CALIFORNIA COASTAL COMMISSION

STAFF REPORT: DE NOVO HEARING

Appeal Number: A-3-SNC-14-0001

Project Description: Construct a 340-room resort complex including a 235-room standard operating hotel, a 105-room condominium hotel, two restaurants, a conference center, onsite parking, a wellness spa, on and offsite road improvements (including to Sand Dunes Drive and Tioga Avenue), public restrooms, a lifeguard station, public access and parking, and related development.

Figure 9

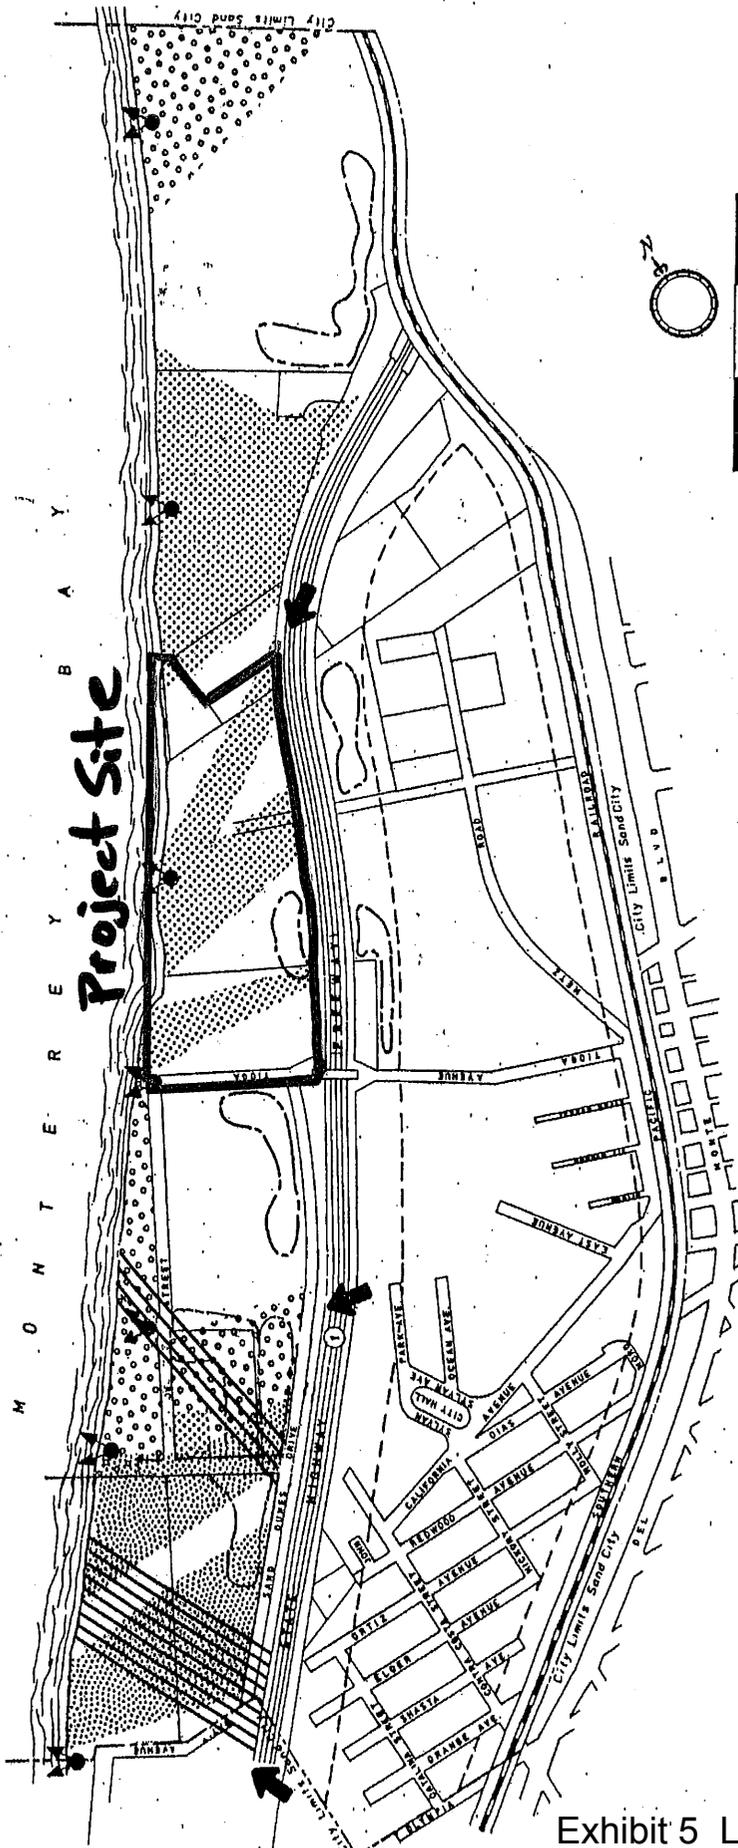
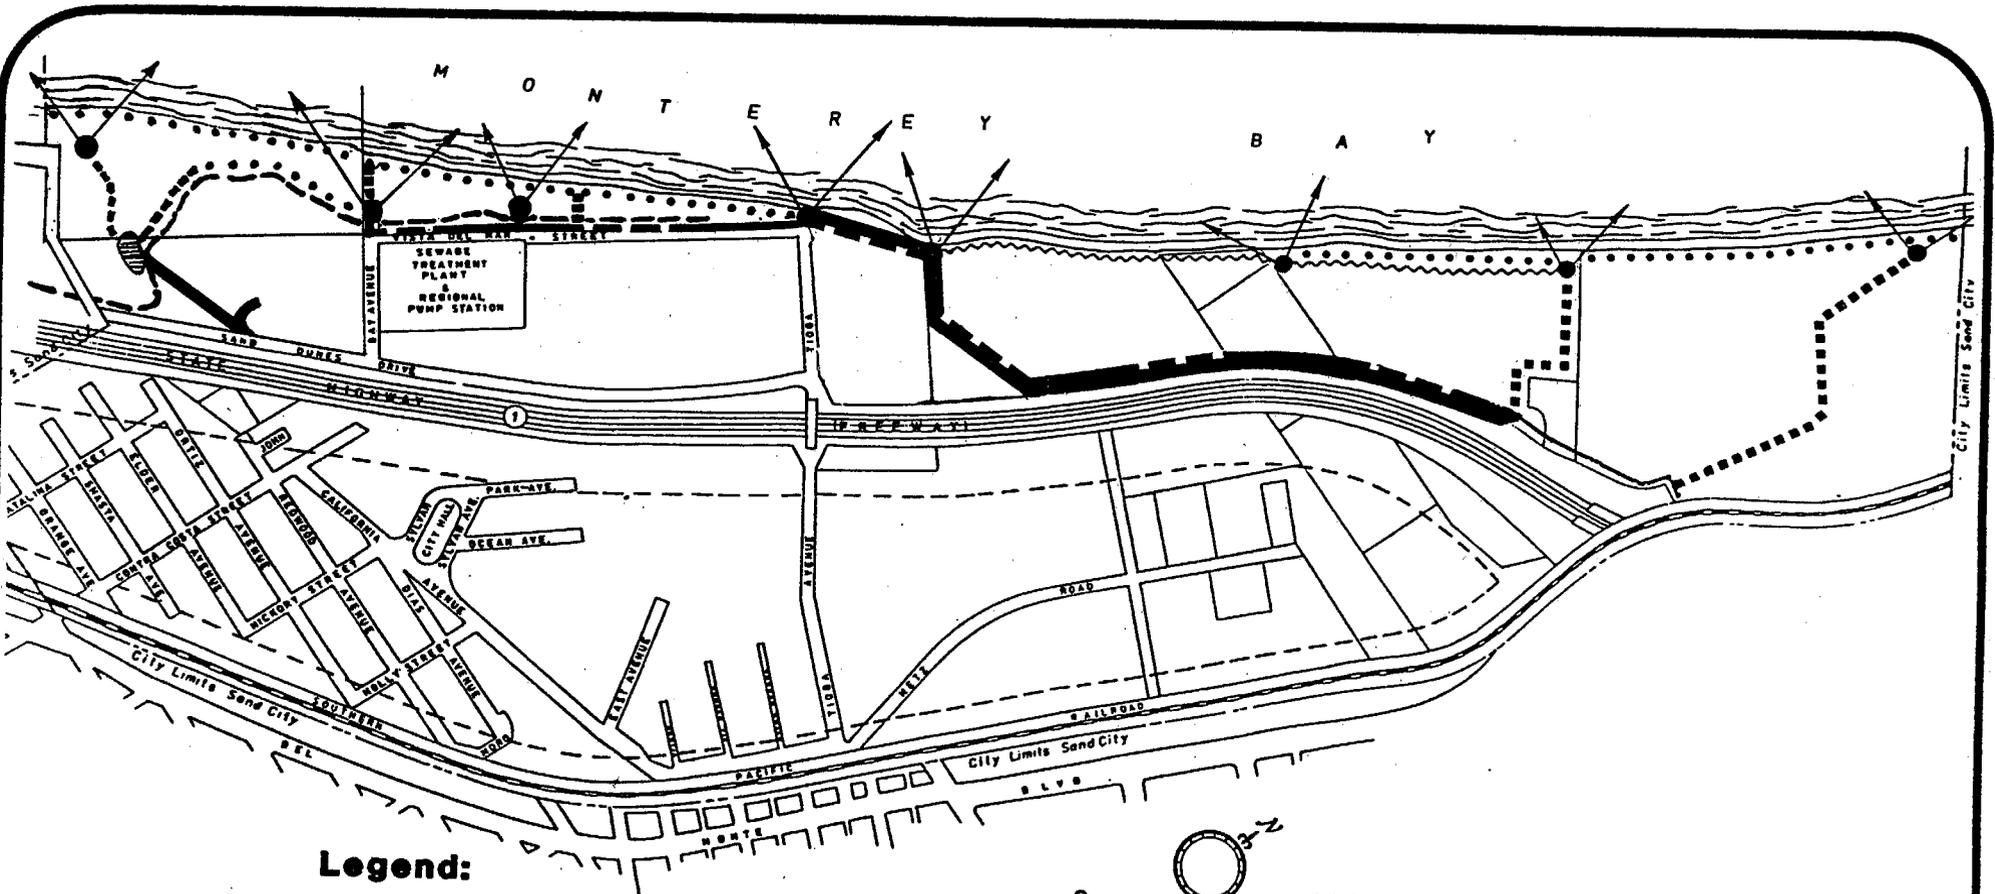
Significant portions of the proposed development site are designated in LUP Figure 9 (**Exhibit 5**) as requiring these view corridors over development. The LCP allows development to be visible in this location as long as views over the development are protected.

The LCP includes very specific requirements for development on the site. Beginning with the view corridors identified in Figure 9 (**Exhibit 5**), development within these view cones must adhere to specific view protection performance criteria including that development not intrude upon, or block, an unobstructed view of more than one-third of the lineal distance across the Bay as seen by southbound motorists on Highway One. Within the Visitor-Serving Commercial (VSC) district, the LCP limits hotel/motel/timeshare densities to a maximum of 37 rooms per acre (229 maximum) on the roughly 8-acre Sterling site, 75 rooms per acre (375 maximum) on the 16.25 acre McDonald site, and 37 rooms per acre (141 maximum) on the 2.3 acre Granite site. Development heights for the site are limited to a maximum of 45 feet above existing grade for hotel uses, and are limited to a maximum of 36 feet above existing grade for all other uses and development (and limited to a maximum of 25 feet within 100 feet of Highway One). As indicated in LUP Policy 6.4.1, such maximums are not entitlements, but rather upper thresholds that can be considered but that must be understood in relation to site constraints that affect development (including explicitly in terms of protecting natural landforms and views to the Bay) and that limit allowable densities and scale otherwise. Development of the uses identified requires a planned unit development (PUD) approval, and that approval requires the project to be consistent with CEQA, including appropriate environmental review.

Exhibit 1

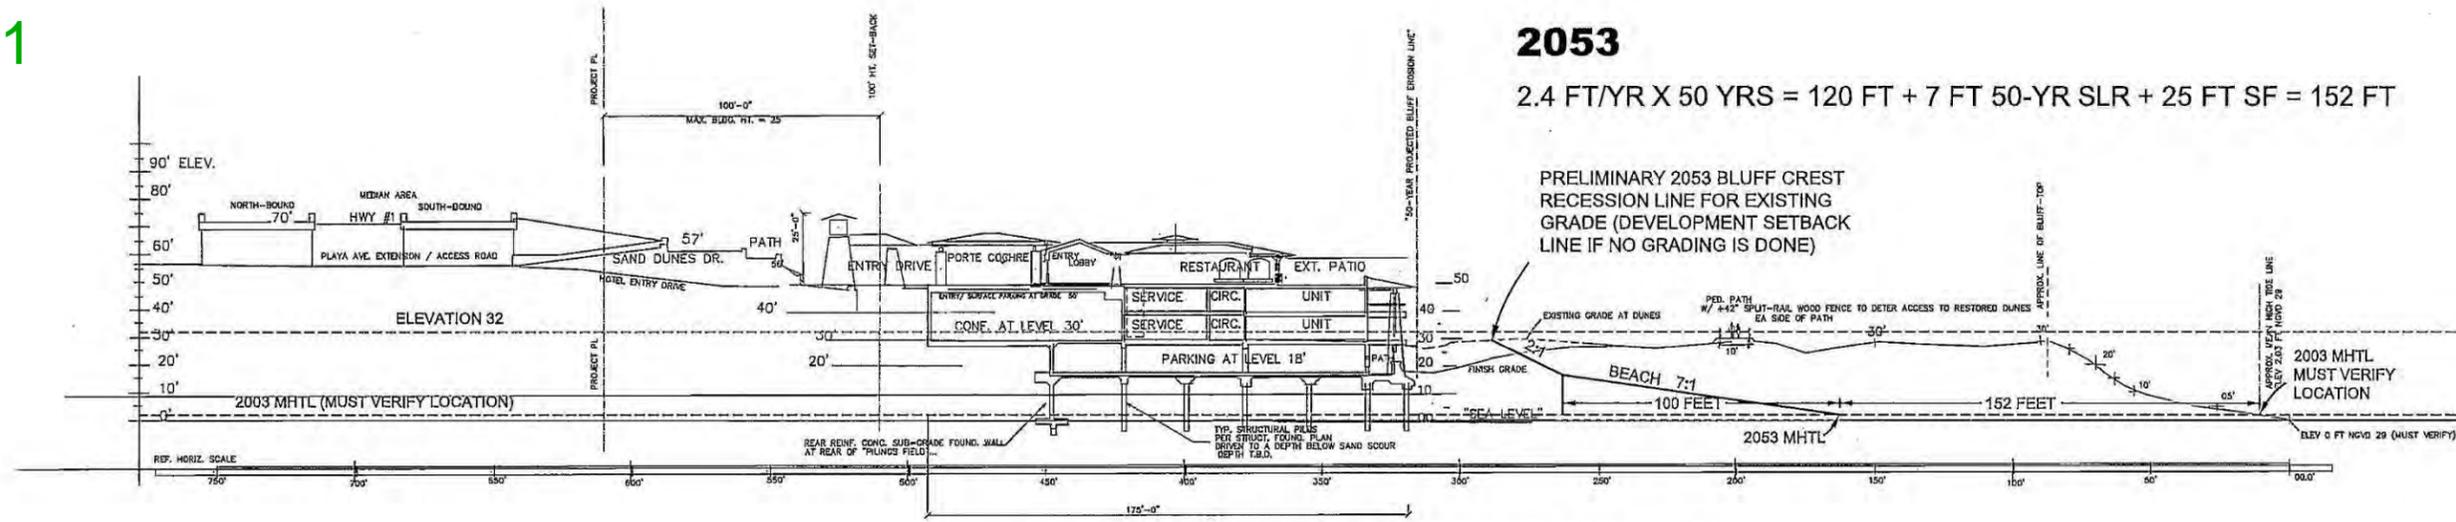
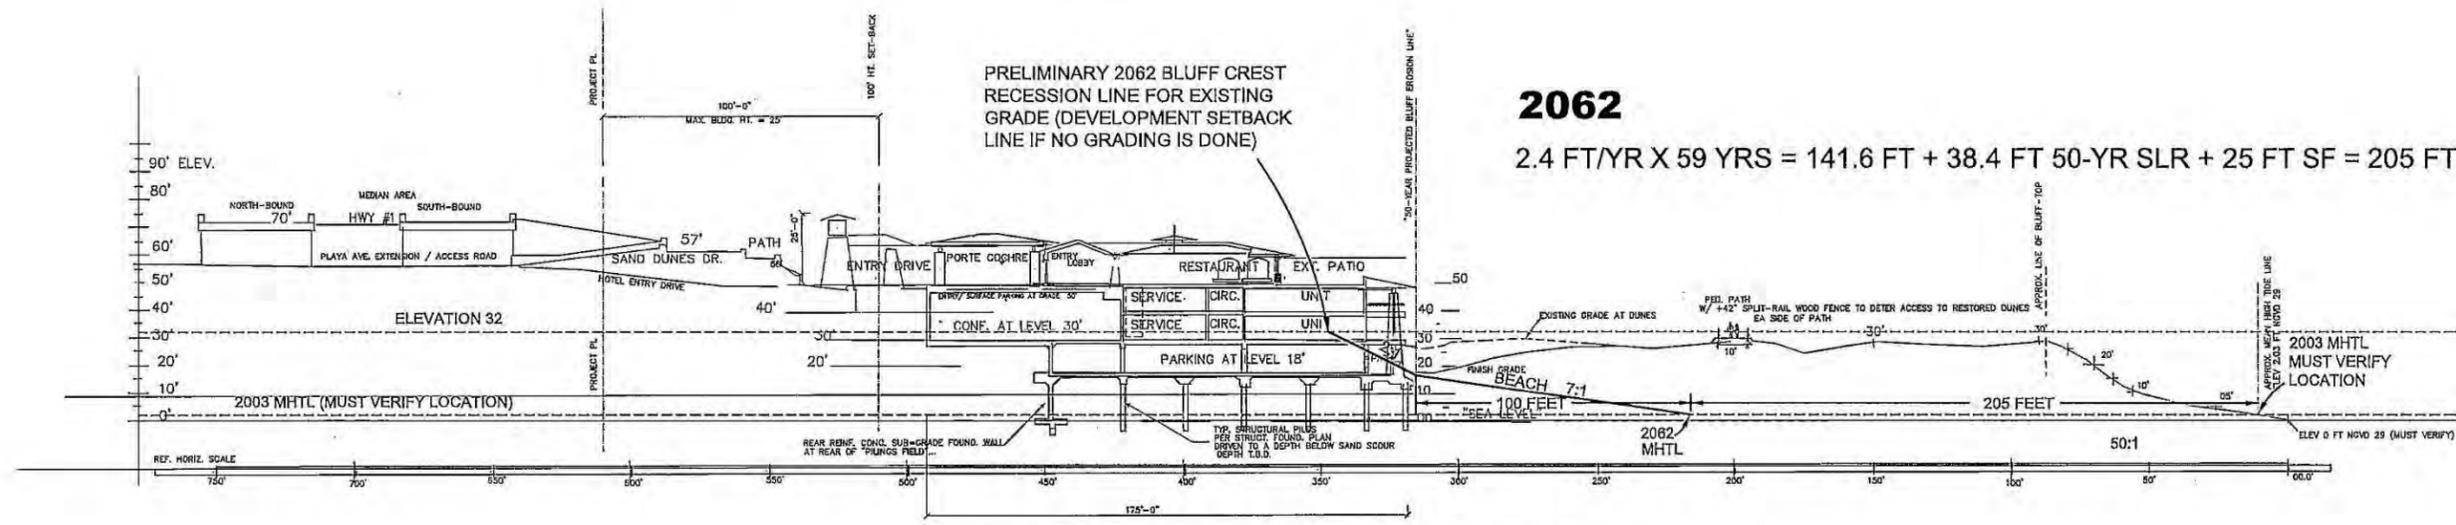
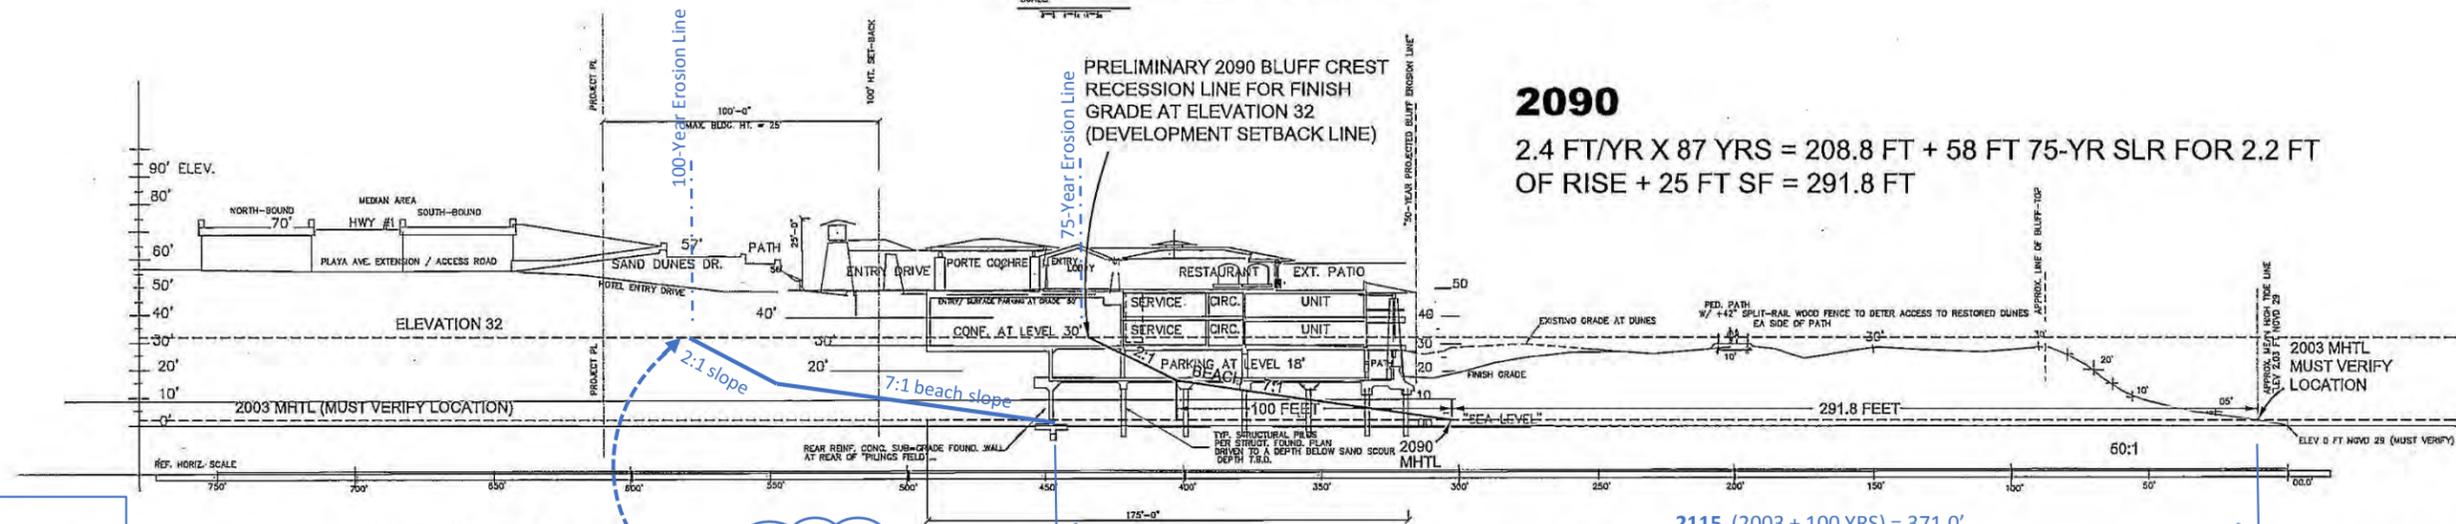
This is not the methodology followed by the Applicant’s geotechnical consultants in references (2) and (3), shown in Exhibits 1 and 2, and described below. I do, however, find their methodology acceptable. Nevertheless, as I will describe in more detail below, I find the following problems with the “erosion lines” shown on Exhibit 2:

- 4) The “erosion lines” depicted in Exhibit 2 were not drawn by the Applicant’s geotechnical consultants based on calculations from multiple cross sections but were extrapolated by the Applicant’s land use planning consultant based on a single cross
